SUBJECT: Forwards response to NRC 850603 request for addl info on NUREG-0737, Item III.D.1, "Performance Testing of Relief & Safety Valves." PURV control circuit components located in cable room & not subj to harsh environ.

Subject: Oconee Nuclear Station
Docket Nos. 50-269, -270, -287

Duke Power Company
Oconee Nuclear Station
Attachment 1
Response to NRC's
Request For Additional Information
Concerning Performance Testing
Of Relief and Safety Valves

Figure 1

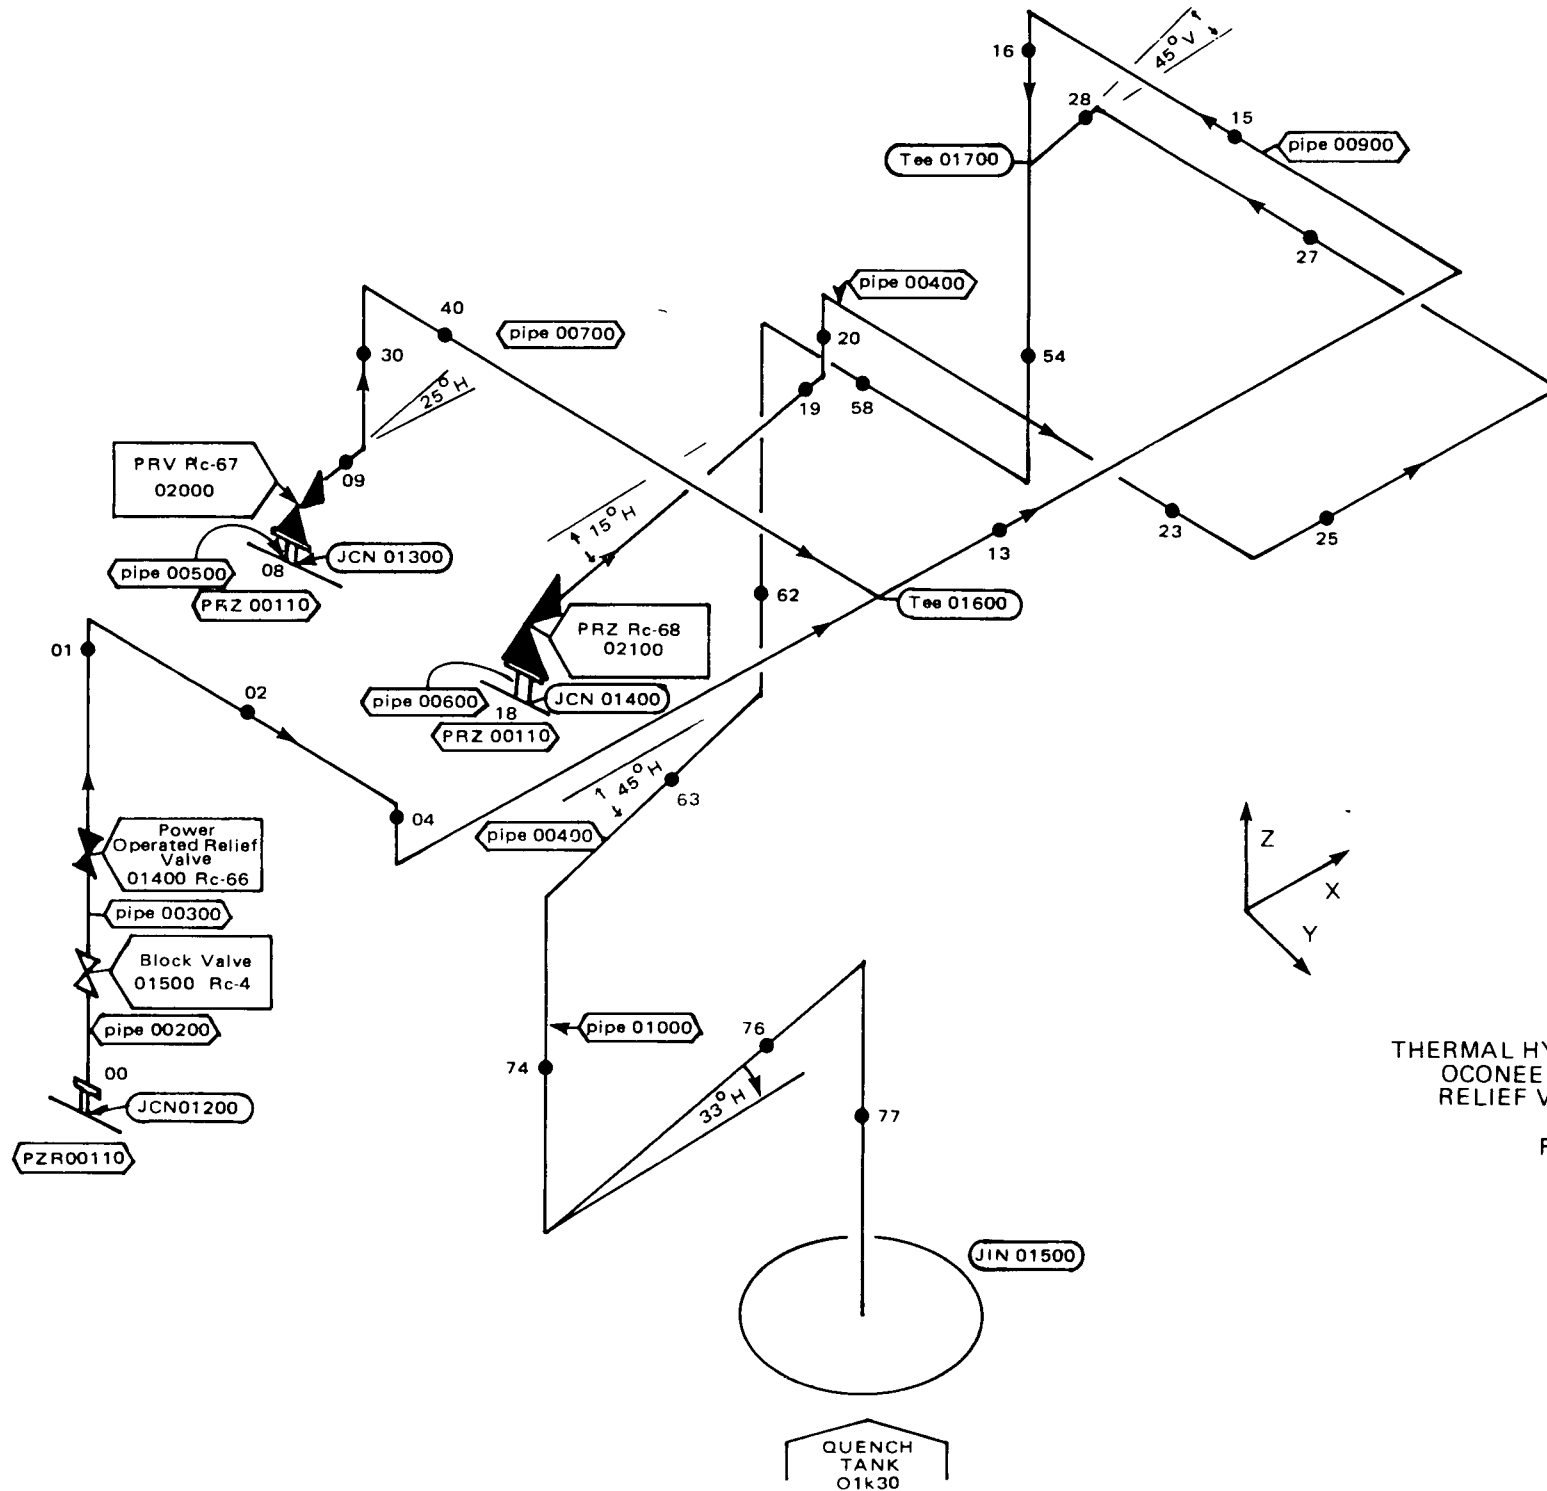
- (e) A discussion of the sequence of opening of the safety valves that was used to produce worst case loading conditions.
- (f) A sketch of the thermal hydraulic model showing the size and number of fluid control volumes.

- (f) In order to satisfy the Courant limit for the time step size selected (0.01 millisecond), piping volumes were selected to be two feet long or less. The requested sketch is attached as Figure 1.
- (g) The thermal hydraulic analysis is documented in Duke Power Company calculation OSC 1692, dated August 24, 1982, which is available for inspection at our Charlotte office. There is no formal report of the thermal hydraulic analysis available for distribution. We are unable to locate the report requested in the NRC question, however, we believe it refers to a preliminary version of Reference 9. EPRI reports are available from the Research Reports Center, P. O. 50490, Palo Alto, CA 94303.

FIGURE 2

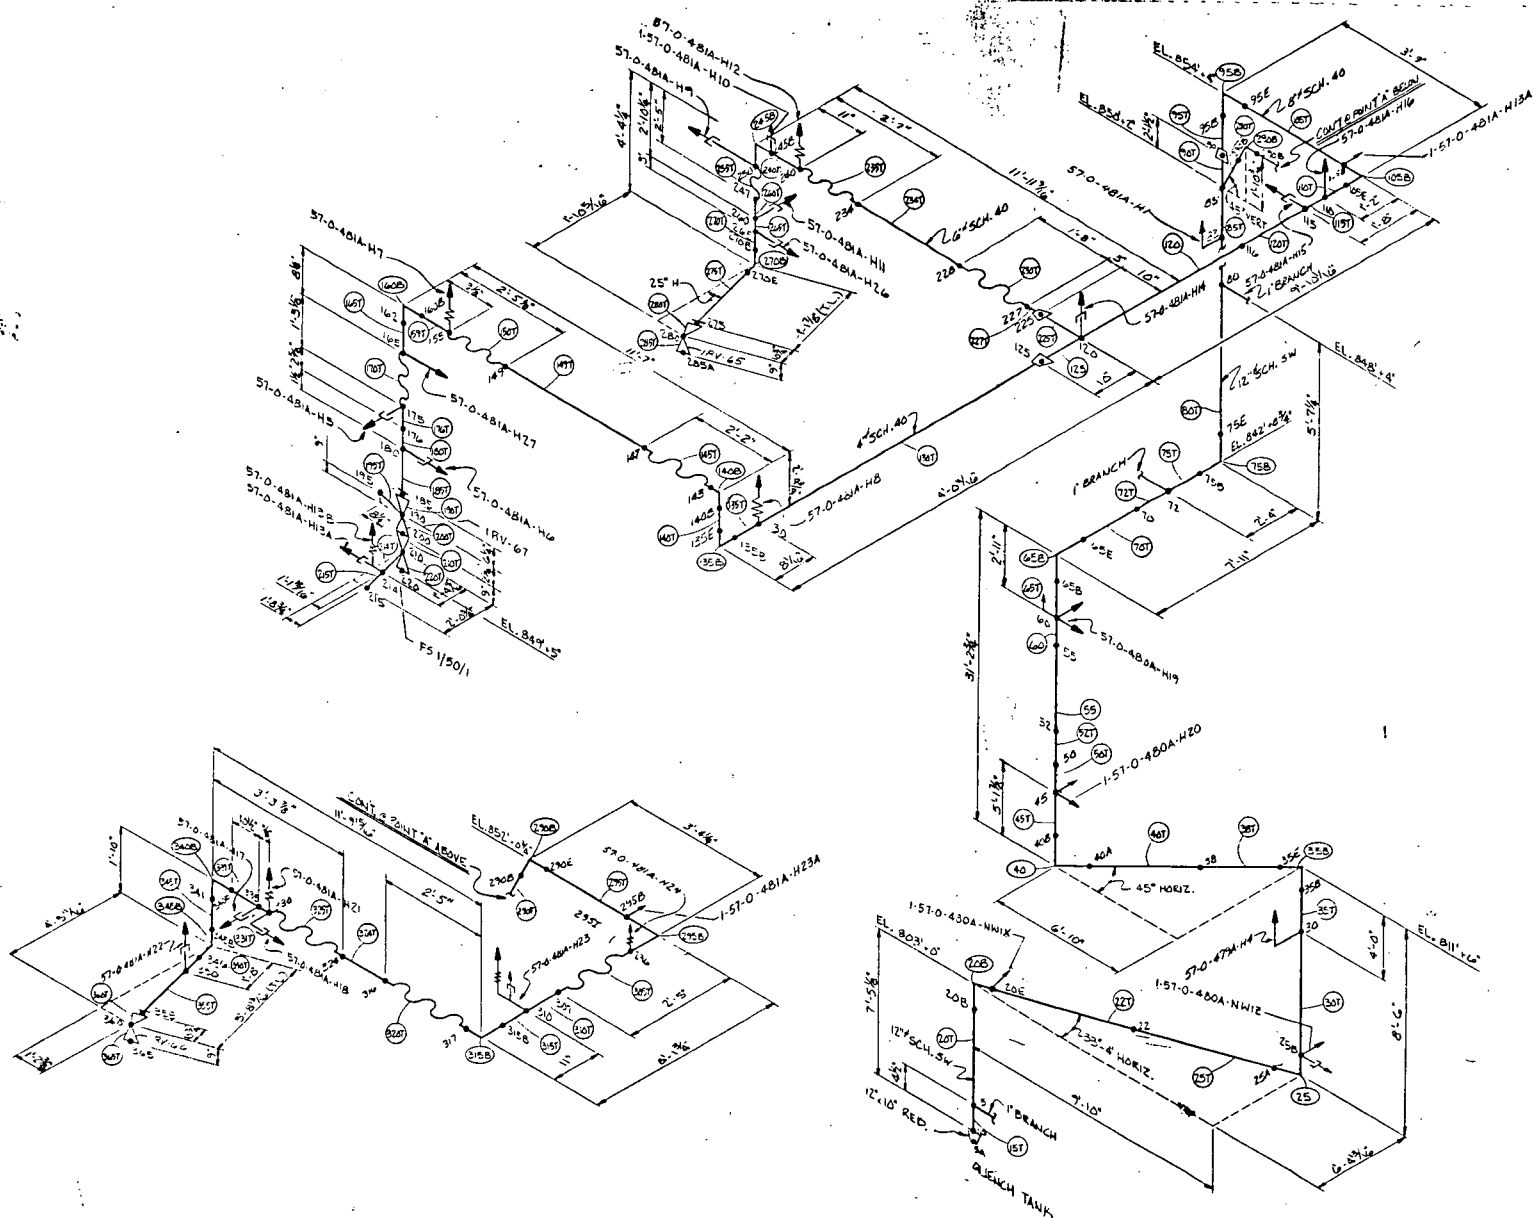
- e. A sketch of the structural model showing lumped mass locations, pipe sizes, and application points of fluid forces.
- f. A copy of the structural analysis report as well as a copy of the EPRI report referenced in the submittal, Determination of As-Tested Bending Moments Acting on Test Valve Discharge Flanges.

- (e) The 'As-Built' analysis isometrics of the Units 1 & 3 Pressurizer Relief Valve systems are attached as Figures 2 and 3. The Unit 1 isometric is applicable to both Units 1 & 2. The computer program 'SUPERPIPE' automatically generates lumped mass points. Masses are lumped at points of discontinuity and at a maximum of "L" in straight pipe, as defined below:
